# Docket Item #10 Development Special Use Permit #2022-10018 Vacation #2022-00002 Restaurant Depot, 4600 Eisenhower Avenue

Consideration of a request to amend to DSUP#2009-0003 for a new development special use permit and site plan, with modifications, to construct a 27,123 GSF expansion to an existing building; and a request to vacate approximately .72 acres (31,314 SF) of City right-of-way.

Attachment 1: Applicant exhibit for 10' shared use path, dated 9/12/22

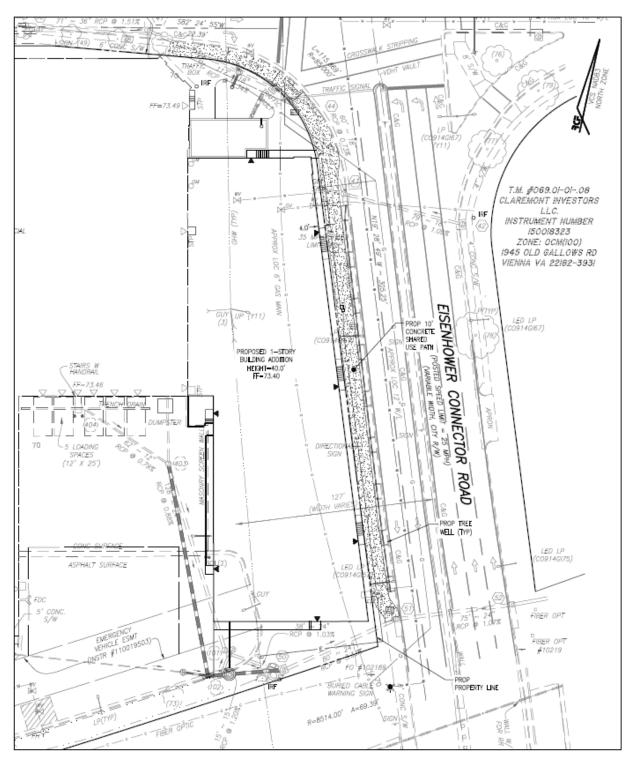
- 30. Provide a 10-foot concrete multi-use path along the site frontage of the Eisenhower Connector as shown in Attachment #1 per the City's Transportation Management Plan, Pedestrian and Bicycle Mobility Plan, and the Eisenhower West Small Area Plan. (T&ES)
